Rezoning Transportation Analysis

Petition Number: Zoning Petition #2021-004

General Location Identifier: Tax ID 08117410

Date	Description
02-25-21	First Review (WB)

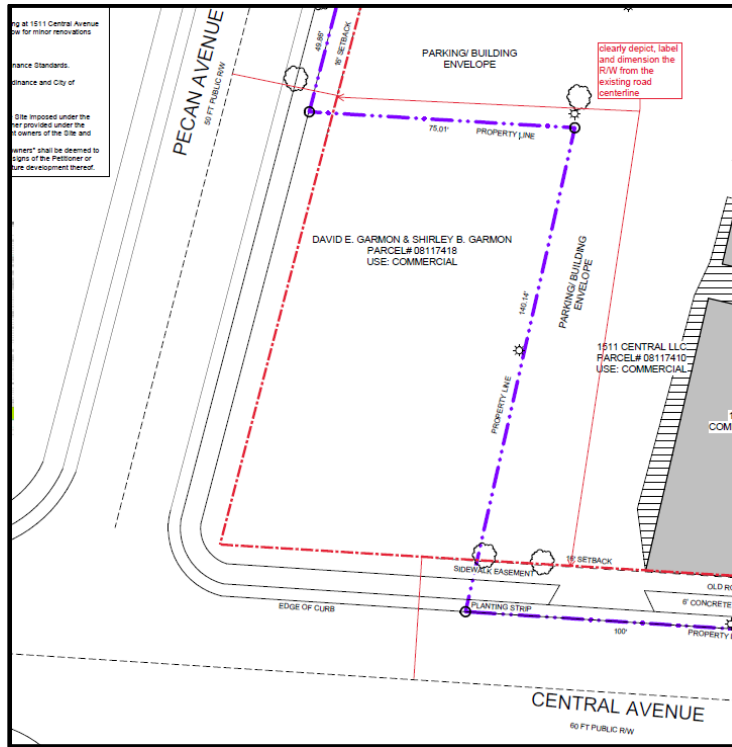
Label and dimension the existing curb and gutter from the centerline for each road on the site plan.

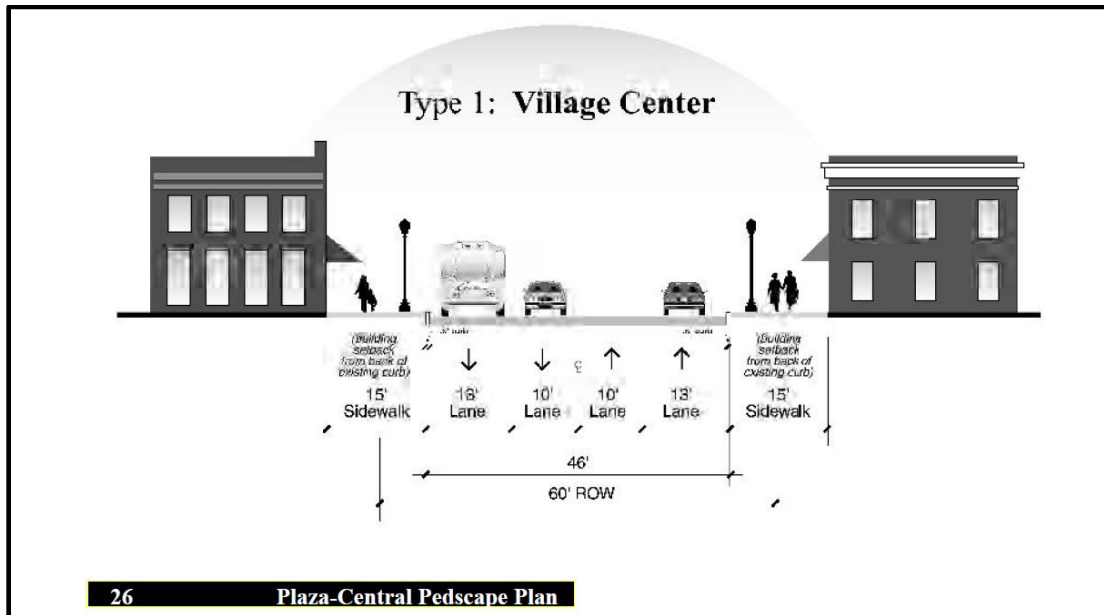
- Revise site plan and conditional note(s) to commit to providing a 15' sidewalk at the back of curb on Central Avenue, per Chapter 19 and the Plaza-Central Pedscape Plan. The site plan shall label and dimension the sidewalk from the back of curb and gutter.

- Revise site plan and conditional note(s) to commit to construct an 8-foot planting strip, and an 8-foot sidewalk on Pecan Street per Chapter 19, CLDSM U-05A and the Plaza-Central Pedscape Plan. The site plan shall label and dimension both items from the back of curb and gutter.

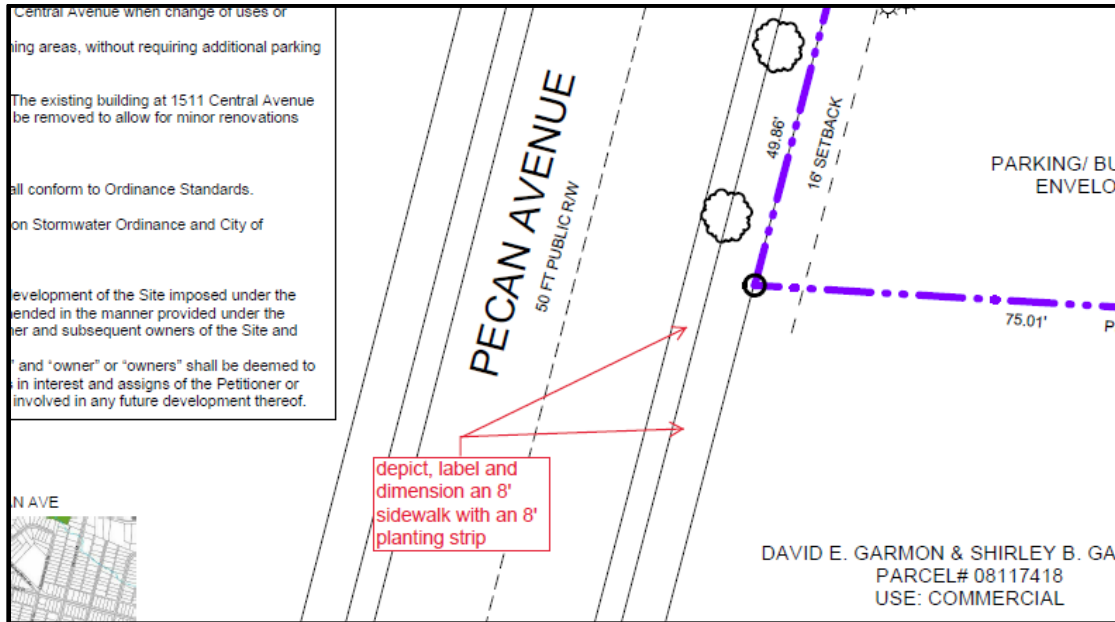
Revise site plan Conditional Note II.d. to the following: "To not require the installation of streetscape improvements along Central Avenue when change of uses or building expansions occur if Chapter 19 is not triggered. Should a future building expansion trigger Chapter 19 requirements, pedestrian and drainage facilities will be required."
